PRAIRIE VILLA AT BEACON HILL WICHITA, SEDGWICK COUNTY, KANSAS

RE: SUB 2004-11 -- One-Step Final Plat of Prairie Villa at Beacon Hill Addition

CASE NUMBER: SUB 2004-11 -- PRAIRIE VILLA AT BEACON HILL ADDITION

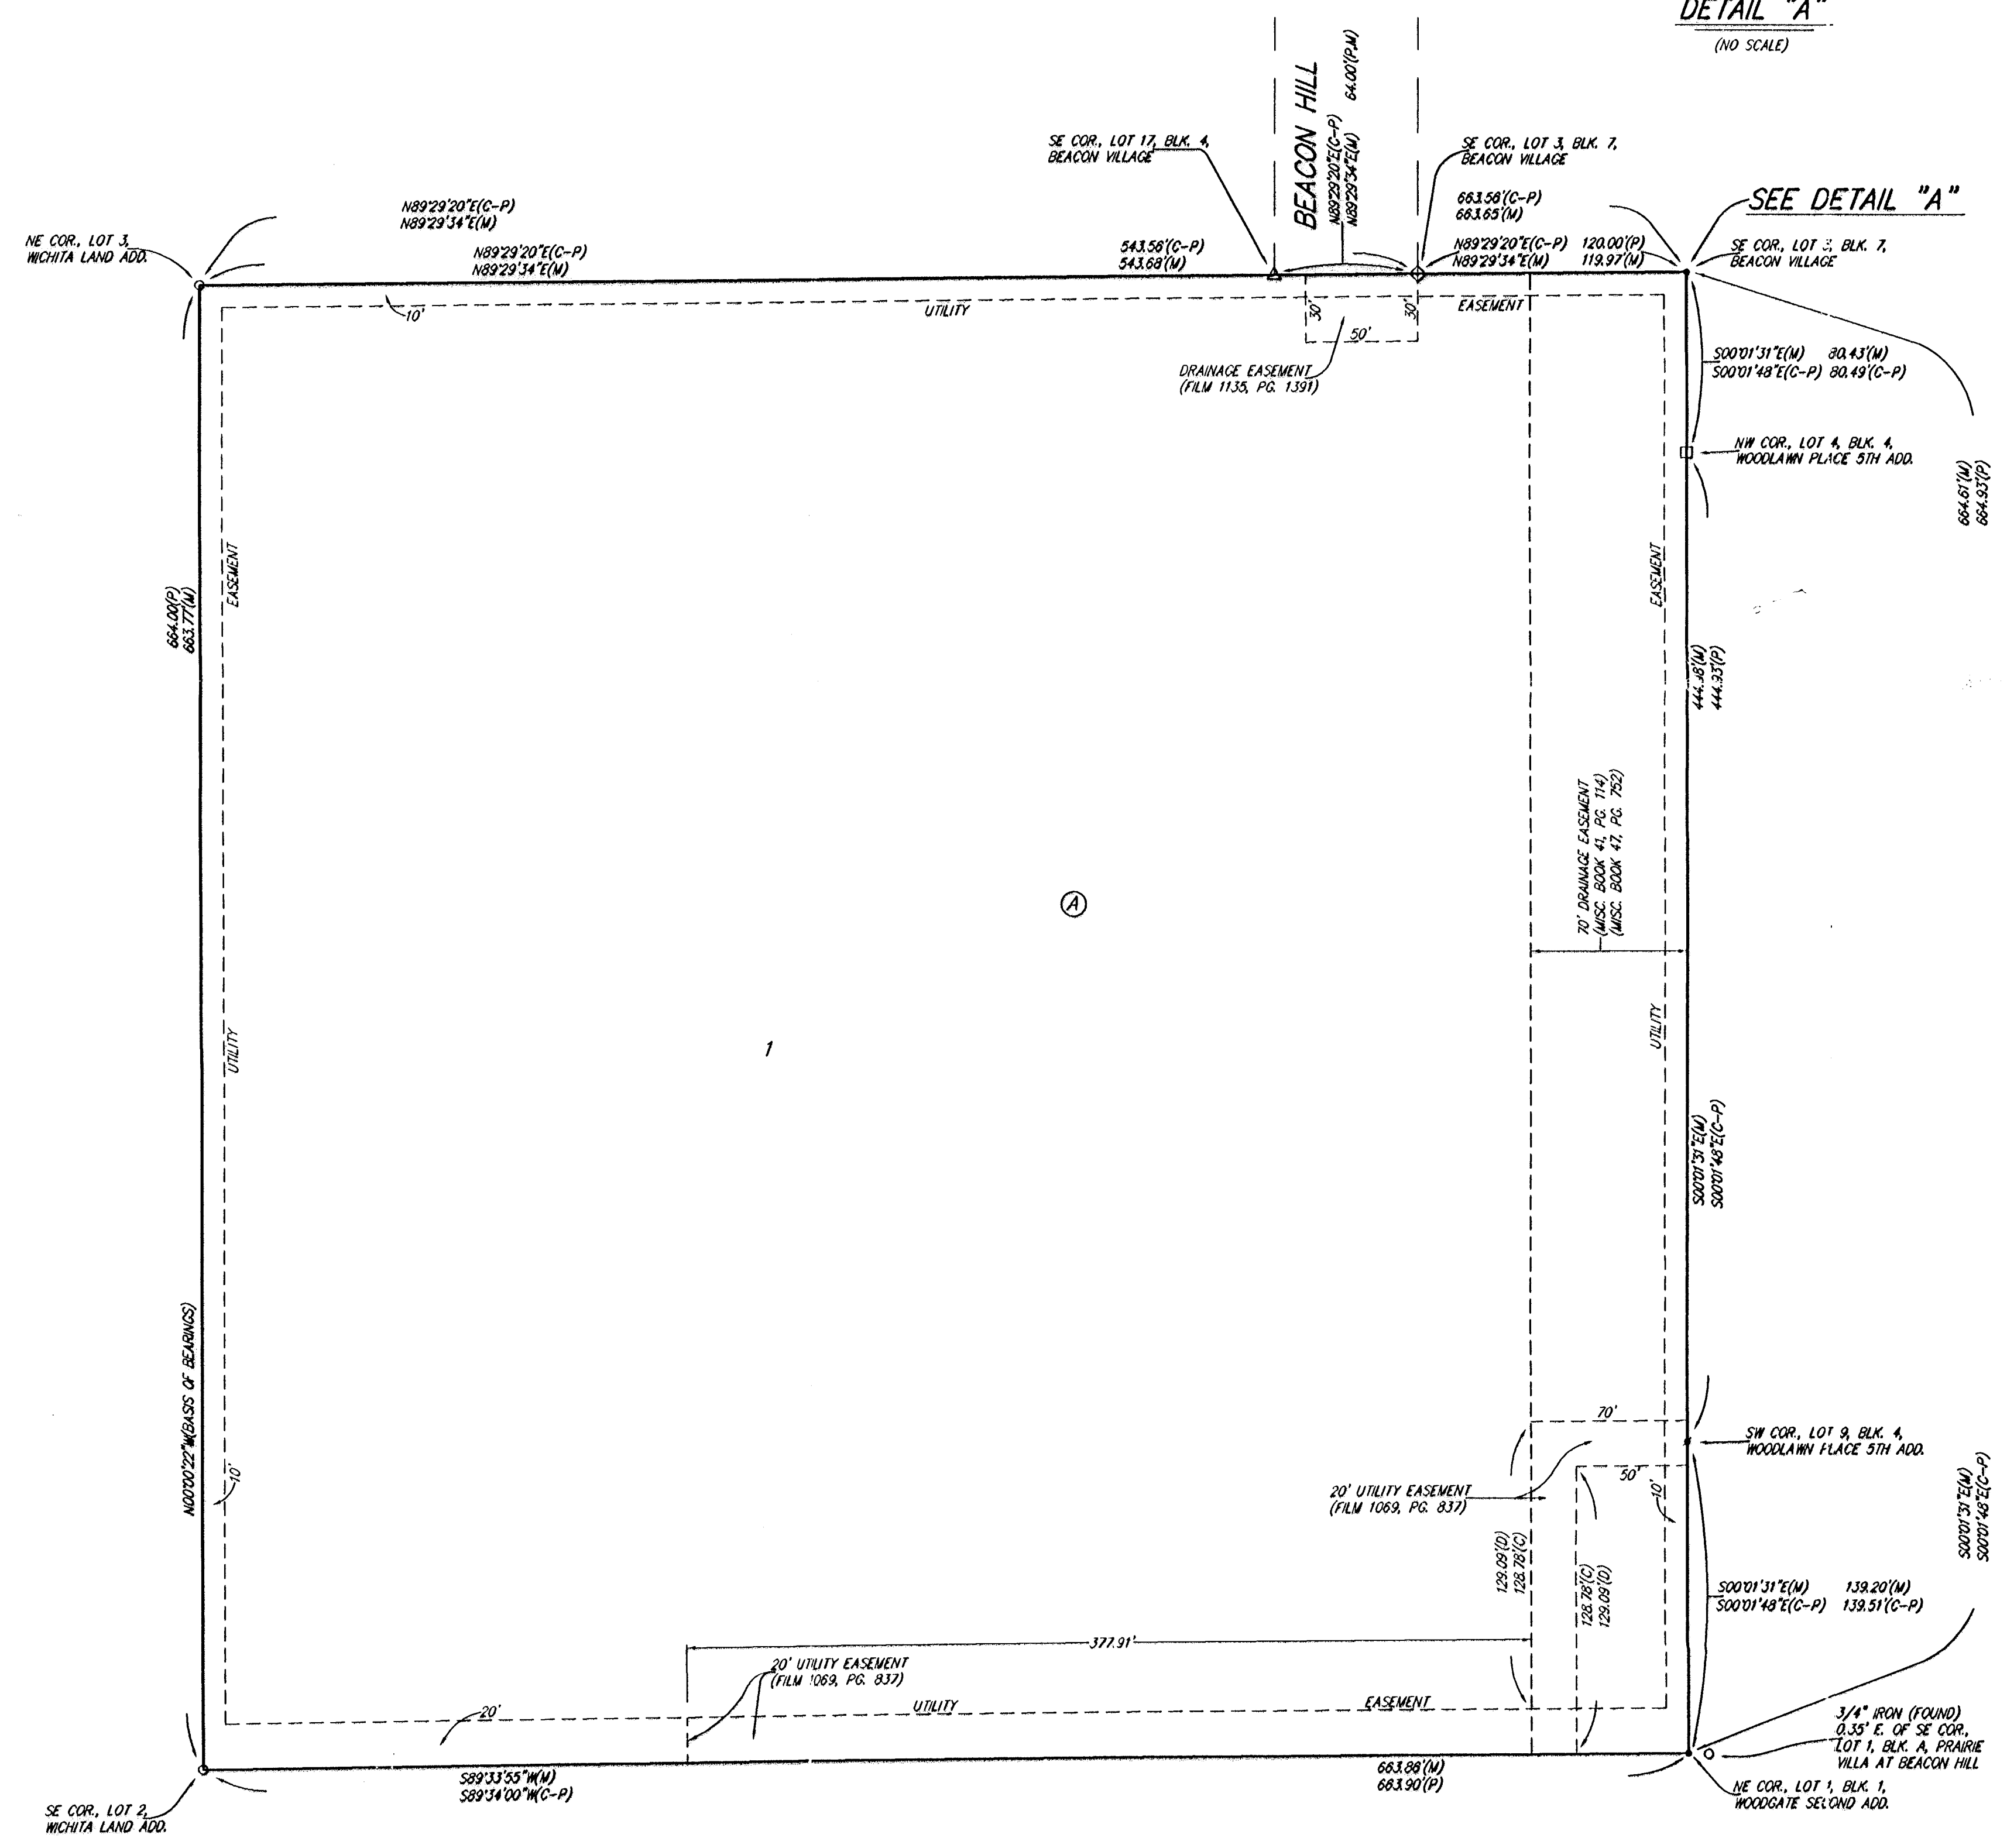
- C. City Engineering needs to comment on the status of the applicant's drainage plan. City Engineering has requested a drainage easement.
- D. City Fire Department needs to comment on the need for a turnaround. In lieu of a public right-of-way turnaround, a private drive circulation system is required with a 20-ft paved surface, 35-ft radius turnarounds or as approved by City Fire Department; and a 29-ft roadway at the entrance.

- F. The platator's text shall include language that a drainage plan has been developed for the plat and that all drainage easements, rights-of-way, or reserves shall remain at established grades or as modified with the approval of the applicable City or County Engineer, and unobstructed to allow for the conveyance of stormwater.

NOTE:
A DRAINAGE PLAN HAS BEEN DEVELOPED FOR THIS SUBDIVISION AND IS ON FILE WITH THE CITY OF WICHITA, KANSAS. DRAINAGE INTENT SHALL REMAIN AS DEPICTED OR AS MODIFIED WITH THE APPROVAL OF THE CITY ENGINEER OF THE CITY OF WICHITA, KANSAS. NO OBSTRUCTIONS WHICH IMPEDE THE FLOW OF THIS DRAINAGE PLAN SHALL BE ALLOWED.
